Regarding on roll bars

FORMULA DRIFT
J A P A N

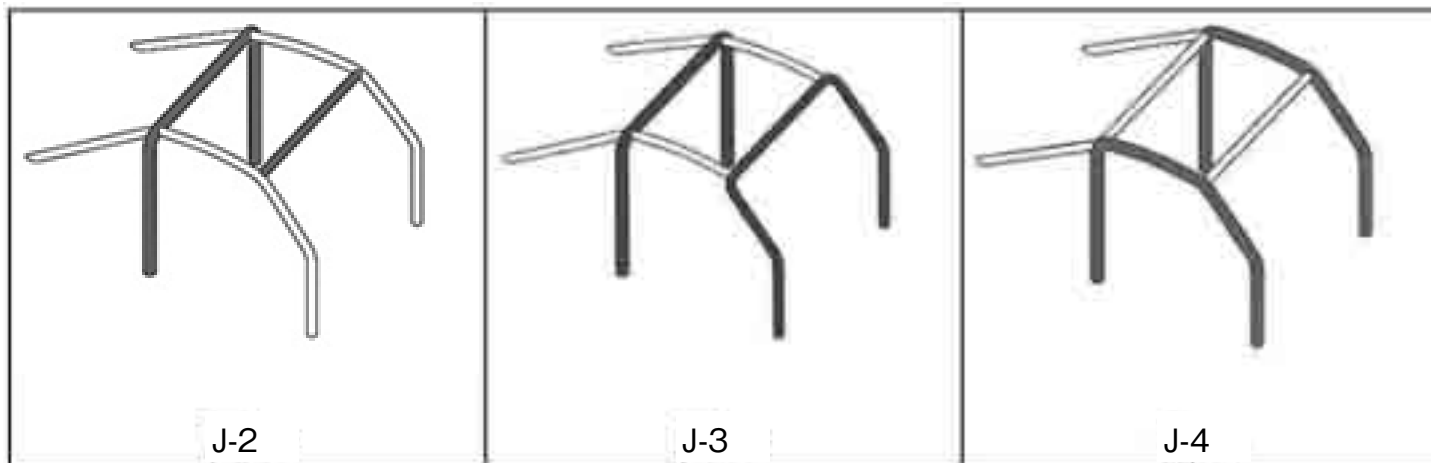
In 2018 including the main hoop, use of 40mm 2mm thick was approved. (However, it may be 45 pie in 2019)

The gray part(Main Roll bar) of the illustration(J-2/J-3/J-4) must use 44.45mm x 2.5mm or 50mm x 2.0mm.

There is no structural mitigation, but with the above structure, we were able to admit the use of 40mm x 2 mm thick pipe including main hoop also in 2018.
